## TECHNICAL MEMORANDUM

DATE **Project No. 21453907** June 12, 2023

LAFARGE GOODWOOD PIT EXTENSION: RESPONSE FOR REGIONAL MUNICIPALITY OF DURHAM APPENDIX C SITE SCREENING QUESTIONNAIRE FORM

Attachments: Figure 5: Groundwater Hydrographs

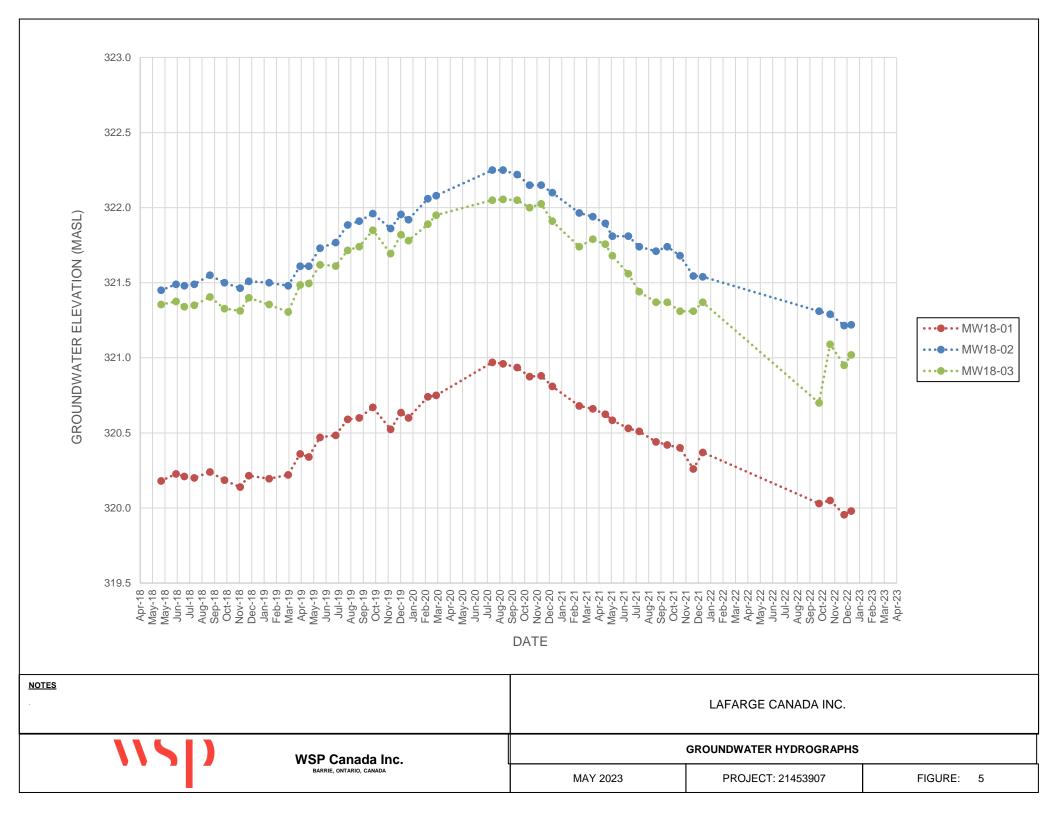
Groundwater level monitoring of the three monitoring wells at the Site began in May 2018 with monthly monitoring events occurring thereafter. Based on this monitoring, and the inferred natural groundwater flow direction is northward across the site (see Figure 5 and 6 from Golder 2023 attached). This is confirmed by regional groundwater modelling undertaken for the Regional Municipality of Durham, which suggests that the Site is just downgradient of a regional groundwater divide within the Oak Ridges Aquifer complex (ORAC) with groundwater flowing in a generally northwards direction through the Site (Earthfx, 2010). As the railway

Figure 6: Inferred Water Table

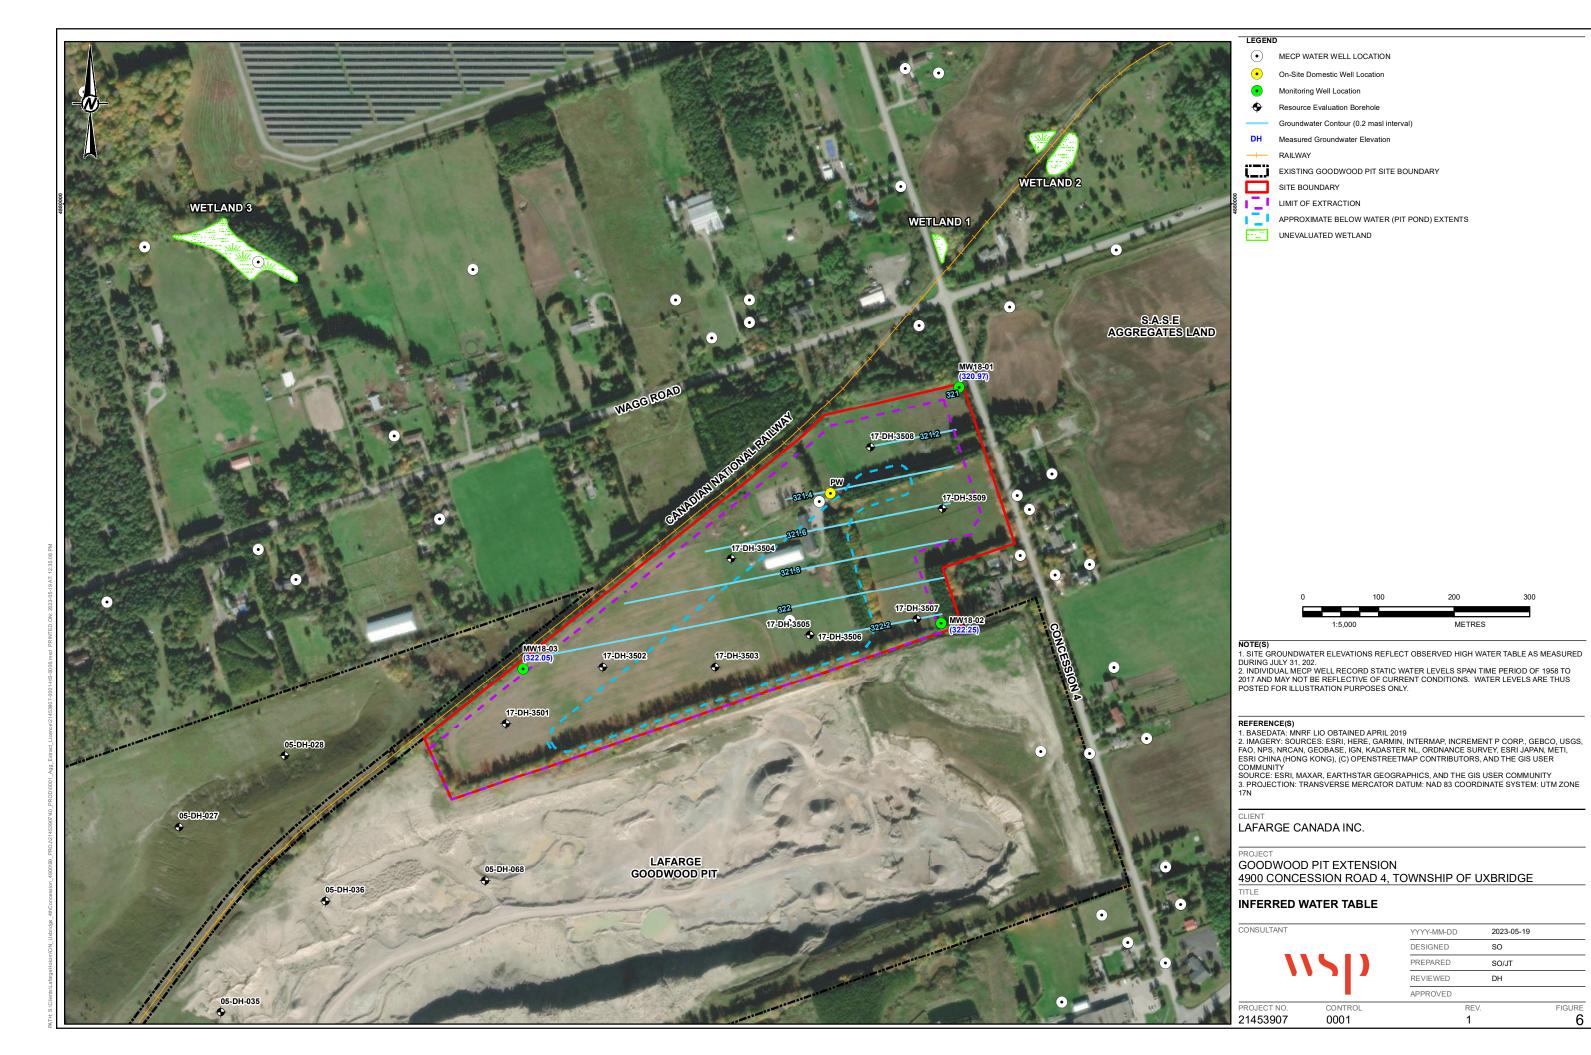
corridor is located north of the Site, natural groundwater flow is inferred to be from the site toward the railway. As such, any contaminants in the railways would be flowing away from the site and not toward it.

Baseline groundwater quality conditions were evaluated by taking water samples from the three monitoring wells and the on-Site domestic well during September and October 2018 (well locations shown in Figure 6 from Golder 2021). Follow up sampling events occurred during April 2019 and October 2020. The groundwater samples were analysed for inorganic water quality parameters including metals, bacteria, Polycyclic Aromatic Hydrocarbons (PAHs), Volatile Organic Compounds (VOCs), and Petroleum hydrocarbons (PHC) (F1 – F4). Parameter concentrations were compared to "Table 2: Full Depth Generic Site Condition Standards [SCS] in a Potable Ground Water Condition" from the Ministry of Environment, Conservation and Parks (MECP) *Soil, ground water and sediment standards for use under Part XV.1 of the Environmental Protection Act*, dated July 1, 2011.
